INDESIT company

Model type:
ARTXD149EU/HA

Commercial code:
F060216

1260310 Exploded views

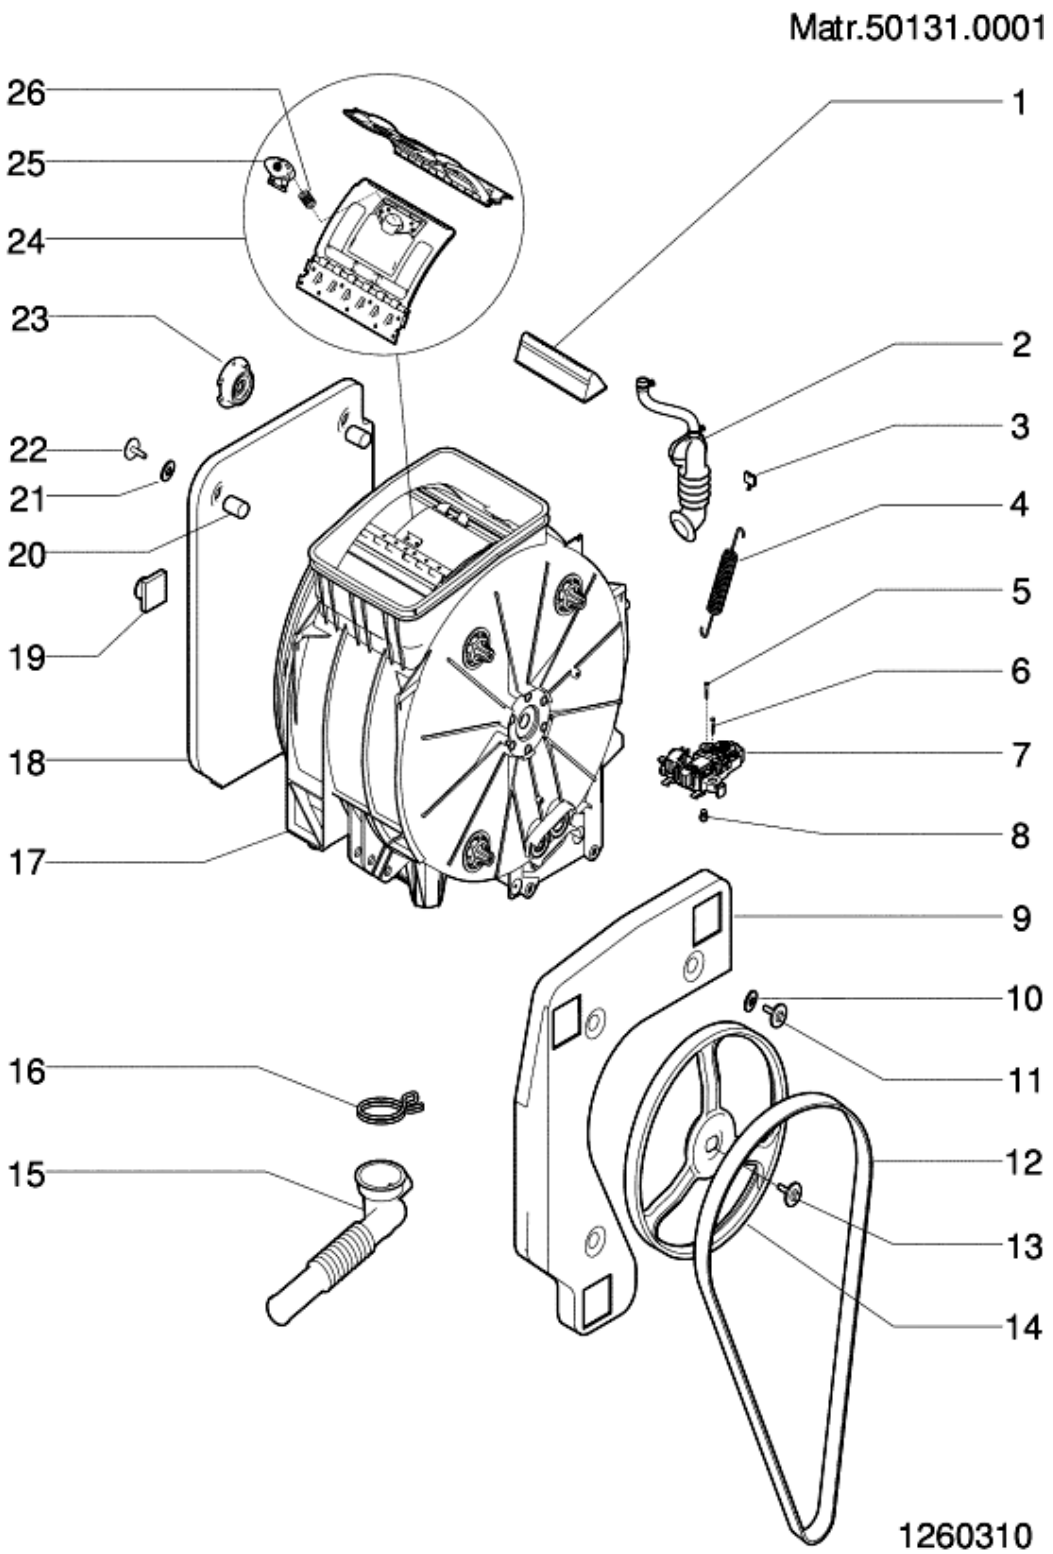
n4009a02: Motor fixing changed on Top Loading washing machines

Top Loading washing machines have changed the fix of motor to the tub.
The tub design is changed in the motor fixing side and two new screws code C00268497 are introduced instead of the old screws C00084333 and the old nut:

C00266015 nut of products with Triphase motor;

C00258673 nut of products with Collector motor.

n4011e13: NEW STEAM EXHAUST HOSE TL INTRODUCED

Spare parts warehouse will go on to manage only the new tubs with the same spare part codes:

C00252343 - Tub 1400 rpm

In assistance on premodification products with the new tubs, you have to fix the motor using the new screws C00268497 instead of the screws and nut that you find in the product.

When the pre-modification items are no longer available, all parts will have to be ordered and replaced.
